CAPTAIN CODE®

Guide to the

2017

NEC® Code Changes

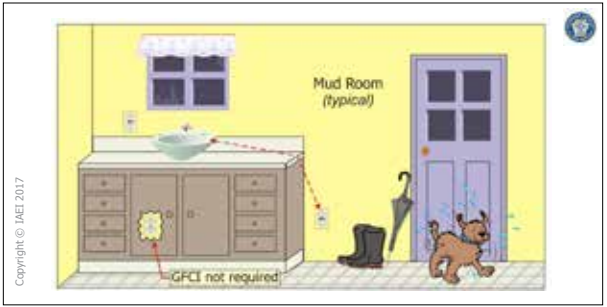
- Measurement criteria at dwelling unit sinks were revised for clarity in determination of which receptacles around these sinks would and would not require GFCI protection.

(6 ft) of any dwelling unit sink required GFCI protection. With literal interpretation, this 2014 NEC modification brought about some unintended circumstances such as mandated GFCI protection for a receptacle under the kitchen sink for a garbage/waste disposer.

This same revision occurred at 210.8(B)(5) for GFCI protection and measurements at a non-dwelling unit sink. Nothing previously stated concerning the measurement methodology at a dwelling unit sink would change for a sink at a commercial office break room or any other non-dwelling unit sink location.

(7) Sinks — where receptacles are installed within 1.8 m (6 ft) of from the outside top inside edge of the sink bowl of the sink.

210.8 Ground-Fault Circuit-Interrupter Protection for Personnel.

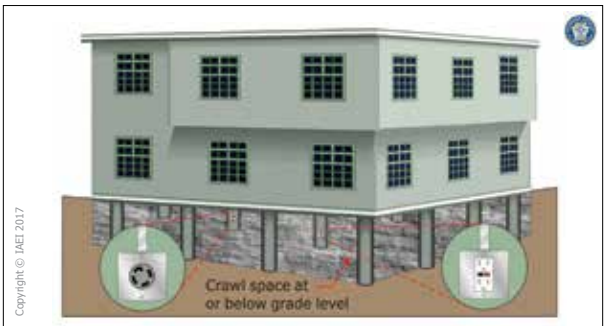
- GFCI protection for receptacles in non-dwelling unit crawl spaces and unfinished basement areas has been added.

The Code has mandated GFCI protection for all 125-volt, single-phase, 15- and 20-ampere receptacles installed in dwelling unit crawl spaces since 1990 and in unfinished basement areas since 1987. From that time until the present, no similar requirement existed for similar receptacles installed in a non-dwelling unit crawl space. That will change for the 2017 NEC with all single-phase receptacles rated 150-volts to ground or less, 50-amperes or less; and three-phase receptacles rated 150-volts to ground or less, 100-amperes or less installed in non-dwelling unit crawl spaces and unfinished basement areas now requiring GFCI protection.

It should be noted that the text at 210.8(A)(5) for GFCI requirement for receptacles in dwelling unit unfinished basements has been revised to match this new text for non-dwelling unit unfinished basements in such a way as to eliminate the need for a definition of an unfinished basement.

(9) Crawl spaces — at or below grade level

210.11 Branch Circuits Required.

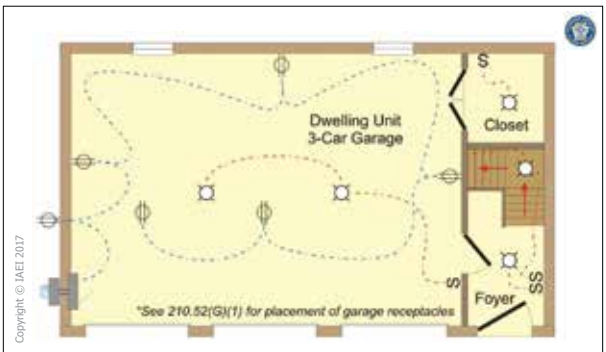
- New requirement added for minimum rated 120-volt, 20-ampere branch circuit for dwelling unit garage receptacles.

A new requirement, which was added to the required branch circuits for dwelling units, calls for at least one dedicated branch circuit for garage receptacle outlets only. This 120-volt branch circuit must have a minimum rating of 20-amperes. An exception was also added to allow readily accessible outdoor receptacle outlets to be supplied from the branch circuit as well. Many of the appliances and tools used in today's dwelling unit garages are rated at 12- to 16-amperes or higher and demand, at least, a 20-ampere rated branch circuit. A 15-ampere rated branch circuit in the modern dwelling unit garage is typically not sufficient for these loads. This requirement was originally proposed at 210.52(G)

(4) Garage Branch Circuits. In addition to the number of branch circuits required by other parts of this section, at least one 120-volt, 20-ampere branch circuit shall be installed to supply receptacle outlets in attached garages and in detached garages with electric power. This circuit shall have no other outlets.

210.52 Dwelling Unit Receptacle Outlets. This section provides requirements for 125-volt, 15- and 20-ampere receptacle outlets.

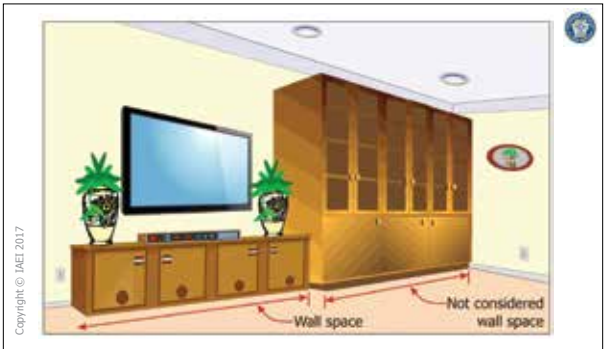
- Fixed cabinets “that do not have countertops or similar work surfaces” was added as an item that will constitute a break in a wall space for receptacle spacing requirements at dwelling units.

For spacing of required receptacles, 210.52(A)(1) states that receptacles are to be located so that “no point measured horizontally along the floor line of any wall space is more than 1.8 m (6 ft) from a receptacle outlet.” What is considered “wall space” and what is not? To answer that question, the provisions of 210.52(A)(2) step forward. During the 2011 NEC revision process, 210.52(A)(2)(1) was revised by adding the term “fixed cabinets” to a list of things that actually would break up a “wall space” that was 600 mm (2 ft) or more in width. These items also include doorways and fireplaces. In reading the substantiation for adding the term “fixed cabinets,” it was quite clear that the cabinets referred to were large cabinets, such as kitchen cabinets. Receptacle placement and spacing for kitchen cabinets and countertops have their set of rules at 210.52(C). The term “fixed cabinets” was added to ensure that the requirements for “1.8 m (6 ft) from a receptacle outlet” wall spacing were not applied to large pantry-type cabinets occupying the space from the floor to the ceiling (with no countertop) in a kitchen area.

This revision for the 2017 NEC at 210.52(A)(2)(1) will eliminate this problem by separating “fixed cabinets,” such as kitchen pantry-type cabinets (but not limited to kitchen cabinets), that do not have countertops or similar work surfaces from short desk-type cabinets with countertops that are clearly intended as work surfaces. This change will ensure that receptacle outlets are required and installed along with these desk-type fixed cabinets that need receptacle outlets for such things as laptop computers, printers, televisions, etc. These fixed desk-type cabinets will be under the same “no point more than 1.8 m (6 ft) from a receptacle outlet” rules as the other walls of that particular room.

(2) Wall Space. As used in this section, a wall space shall include the following:

210.52 Dwelling Unit Receptacle Outlets.

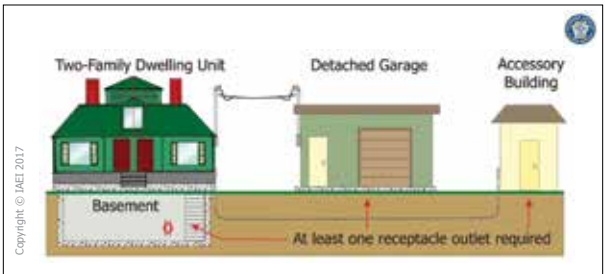
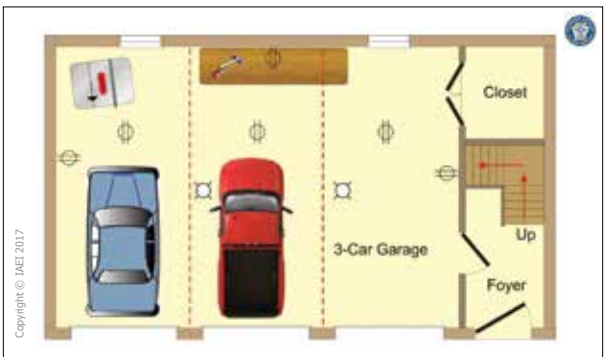
The 2017 NEC text at 210.52(G)(1) was further revised by changing the requirement for at least one receptacle outlet to be installed “for each car space” to “in each vehicle bay and not more than 1.7 m (5½ ft) above the floor.” The change from “for” to “in” each vehicle bay will eliminate the interpretation of one receptacle outlet being shared by two adjacent spaces. The term “car space” was changed to “vehicle bay” to recognize the

fact that other vehicles such as pickup trucks, sports utility vehicles, tractors, and so forth could be parked in a dwelling unit garage as well as a car. The “not more than 1.7 m (5½ ft) above the floor” requirement removes all doubt concerning the receptacle outlet installed in the ceiling specifically for a garage door opener serving double-duty and also serving as the required receptacle outlet “in each vehicle bay.”

This revision also included the relocation of the requirement that the “branch circuit supplying these receptacle(s) shall not supply outlets outside of the garage” from this section of the Code to the new 210.11(C)(4) which pertains to required branch circuits for dwelling units. 210.11(C)(4) will still find a requirement that this branch circuit serve no other outlets, but with an exception allowing readily accessible receptacles located outdoors to be supplied by this garage branch circuit. As a side note, lighting outlets in the dwelling unit garage are still required to be supplied by general lighting circuits and not allowed to be supplied from this newly required 20 ampere rated receptacle outlet branch circuit of 210.11(C)(4) to protect the illumination of the garage area in the event of an outage on the 20-ampere rated receptacle outlet branch circuit.

For a one- and two-family dwellings, at least one receptacle outlet shall be installed in the areas specified in 210.52(G)(1) through (3). These receptacles shall be in addition to receptacles required for specific equipment.

Bonding for Other Communications Systems
250.94(B) Other Means

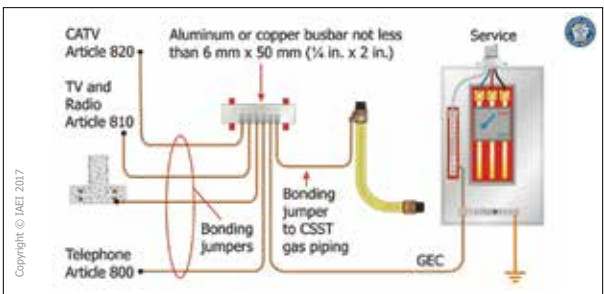
- The title of this section was renamed “Bonding for Communication Systems” and a new 250.94(B) was added titled “Other Means” allowing an alternate connection option to be made on a common bus bar. A new exception was added for 250.94(A) and (B) offering relief from an intersystem bonding connection means “where communications systems are not likely to be used.”

A new 250.94(B) was added titled, “Other Means,” which permits intersystem bonding connections to an aluminum or copper busbar that will accommodate at least three terminations for communication systems as well as “other connections.” This method is often used in commercial or multifamily mixed-use buildings. Even though the previous language was not restricted to just dwelling units and worked well for a dwelling unit, it did not take into account how a commercial or industrial building may bond the communication systems and other systems. Many commercial buildings commonly utilize a common grounding terminal bar for the connection of multiple electrodes and bonding of other systems, such as water piping systems, building steel, and internal antenna systems — to name a few. This new “other means” of terminating other systems allows the installer to terminate other bonding conductors for bonding all systems, including such things as corrugated stainless steel tubing (CSST) gas piping, which is still prohibited to be terminated on the intersystem bonding termination device.

A new exception to 250.94(A) and (B) was also added to give relief from providing a means for connecting intersystem bonding conductors where communications systems are not likely to be used. This exception would include such things as outhouses, chicken coops or garden sheds.

(B) Other Means. Connections to an aluminum or copper busbar not less than 6 mm thick × 50 mm wide (¼ in. thick × 2 in. wide) and of sufficient length to accommodate at least three terminations for communication systems in addition to other connections. The busbar shall be securely fastened and shall be installed in an accessible location. Connections shall be made by a listed connector. If aluminum busbars are used, the installation shall also comply with 250.64(A).

Exception to (A) and (B): Means for connecting intersystem bonding conductors are not required where communications systems are not likely to be used.

250.148 Continuity and Attachment of Equipment Grounding Conductors to Boxes.

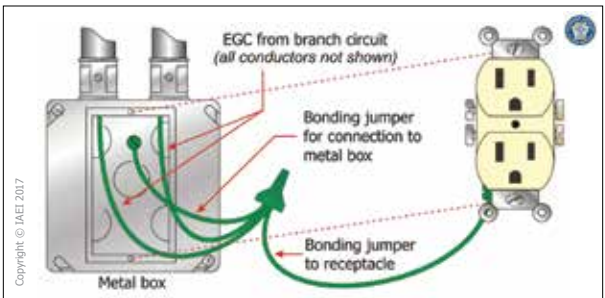
- Revision to clarify that all equipment grounding conductors associated with any and all circuits in the box must be connected together and to the box and not just each equipment grounding conductors of each associated circuit.

The removal of a receptacle or other devices or equipment installed in or on the metal box is not permitted to interrupt or break the continuity of the EGC connections to other equipment or devices that are supplied from the same box where EGCs are connected, or to interrupt or break the continuity of the EGC connections downstream. EGCs installed in nonmetallic boxes are required to provide a means of connecting EGCs to receptacles, switches, luminaires, and other equipment installed in or supplied from the nonmetallic box.

A reference to 250.8 was also added to provide guidance on terminating an EGC or bonding jumper to a metal box or enclosure. Section 250.8 is titled, “Connection of Grounding and Bonding Equipment” and gives eight specific list items on permitted methods to properly connect grounding and bonding conductors to metal enclosures.

Where If circuit conductors are spliced within a box, or terminated on equipment within or supported by a box, any all equipment grounding conductor(s) associated with any of those circuit conductors shall be connected within the box or to the box with devices suitable for the use in accordance with 250.8 and 250.148(A) through (E).

Figure 406.3(E). Controlled Receptacle Marking Symbol.
(see below for symbol)

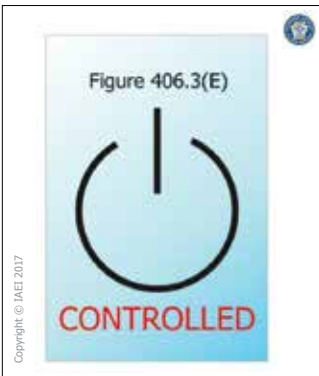
- Receptacles that are controlled by an automatic control device must be permanently marked with the symbol shown in Figure 406.3(E) and the word “Controlled.” Required marking must be on the receptacle face (not the cover plate) and be visible after installation.

For the 2017 NEC, 406.3(E) was revised to provide additional requirements that will help people identify controlled receptacles that are part of an energy management system. One of these revisions requires that the word “Controlled”

be placed on the controlled receptacle along with the previous symbol. The word “Controlled” was also added to Figure 406.3(E). Marking the receptacle with the word “Controlled” will help the end user better understand which receptacle is controlled, even if the end user is not familiar with electrical symbols.

Another change that occurred at 406.3(E) deals with the exact location where the marking of the controlled receptacle is to be placed. For the 2017 NEC, the symbol and the word “Controlled” are to be placed on the face of the controlled receptacle and be visible after installation. The 2014 NEC provisions allowed the symbol to be placed on the receptacle face or the faceplate. If the controlled receptacle marking only appeared on the faceplate, the controlled receptacle itself and its original intended faceplate could be easily separated. An example of this is when the walls are repainted.

All non-locking-type, 125-volt, 15- and 20-ampere receptacles that are controlled by an automatic control device, or that incorporate control features that remove power from the receptacle outlet for the purpose of energy management or building automation, shall be permanently marked with the symbol shown in Figure 406.3(E) and the word “controlled.” For receptacles controlled by an automatic control device, the marking shall be located on the controlled receptacle outlet face where and visible after installation. In both cases where a multiple receptacle device is used, the required marking of the word “controlled” and symbol shall denote which contact device(s) are automatically controlled.

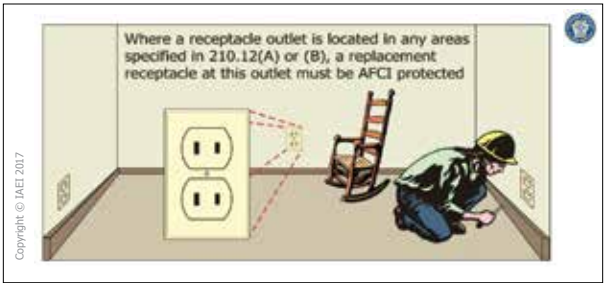
- Two new exceptions were added for AFCI requirements for replacement of existing receptacles.

The parent text of 406.4(D)(4) was revised by removing text concerning the branch circuit providing power to the replaced receptacle, and replacing that text

with a reference to 210.12(A) or (B). This revision will clarify where AFCI protection is required, which is at the receptacle outlet being replaced and not at receptacles located downstream of the replaced receptacle. If a receptacle is being replaced in a bedroom and that branch circuit serves not only that bedroom but a receptacle located outdoors at the front porch, this outdoor receptacle need not be AFCI-protected simply because a bedroom receptacle was being replaced. A literal reading of the previous text could have been interpreted in that way.

The second exception clarifies that the exception to 210.12(D) does not apply when replacing existing receptacles. The requirements of 210.12(D) concern AFCI protection for branch-circuit wiring in areas specified at 210.12(A) when said wiring is modified, replaced, or extended at existing dwelling units. The exception to 210.12(D) permits existing branch-circuit conductors to be modified or extended up to 1.8 m (6 ft) without AFCI protection where no additional outlets or devices are installed.

Exception No. 1: Arc-fault circuit-interrupter protection shall not be required where all of the following apply:

- (1) The replacement complies with 406.4(D)(2)(b).
- (2) It is impracticable to provide an equipment grounding conductor as provided by 250.130(C).
- (3) A listed combination type arc-fault circuit-interrupter circuit breaker is not commercially available.
- (4) GFCI/AFCI dual function receptacles are not commercially available.

Exception No. 2: Section 210.12(B), Exception shall not apply to replacement of receptacles. This requirement becomes effective January 1, 2014.

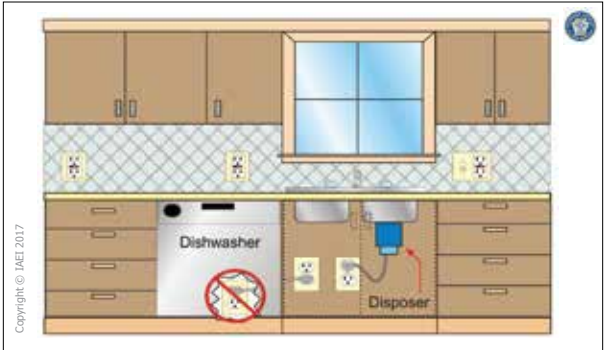
Changes occurred for the 2017 NEC at 422.16(B)(2) which will only permit the receptacle outlet for a cord-and-plug-connected built-in dishwasher to be located “in the space adjacent to the space occupied by the dishwasher.” In previous editions of the Code, the receptacle outlet for a trash compactor or a built-in dishwasher could be located “in the space occupied by the appliance or adjacent thereto” (directly behind the dishwasher). This change corresponds with provisions in the product standard for household dishwashers, UL 749.

This change brings the NEC in agreement with Section 8.3.3(a) of UL 749 which states in part, “the power-supply receptacle for the appliance (dishwasher) shall be installed in a cabinet or on a wall adjacent to the under counter space in which the appliance is to be installed.

To accommodate this potentially extended length of the cord for connection to a receptacle outlet in the adjacent cabinet space, the maximum length of a cord for a built-in dishwasher was extended from the previous length of 1.2 m (4 ft) to 2.0 m (6.5 ft), measured from the face of the attachment plug to the plane of the rear of the appliance.

- (3) For a built-in dishwasher, the length of the cord shall be 0.9 m to 2.0 m (3 ft to 6.5 ft) measured from the face of the attachment plug to the plane of the rear of the appliance.

- (6) The receptacle for a built-in dishwasher shall be located in the space adjacent to the space occupied by the dishwasher.

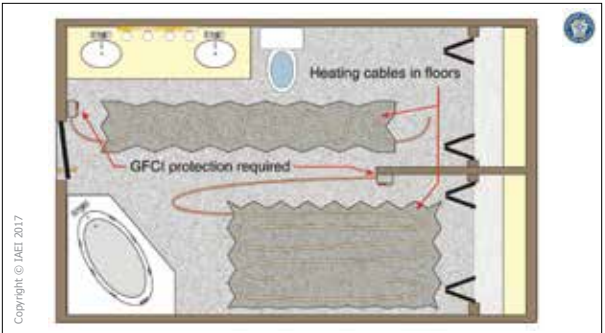
- New requirements were added for the installation of heating cables installed under floor coverings.

was added. This practice is not new to the electrical industry, but installation requirements for these under flooring heating cables is new for Article 424. These types of heating cables are required to be GFCI protected.

(C) Connection to Conductors. Heating cables shall be connected to branch-circuit and supply wiring by wiring methods described in the installation instructions or as recognized in Chapter 3.

(D) Anchoring. Heating cables shall be positioned or secured in place under the floor covering, per the manufacturer's instructions.

(E) Ground-Fault Circuit-Interrupter Protection. Ground-fault circuit-interrupter protection for personnel shall be provided.
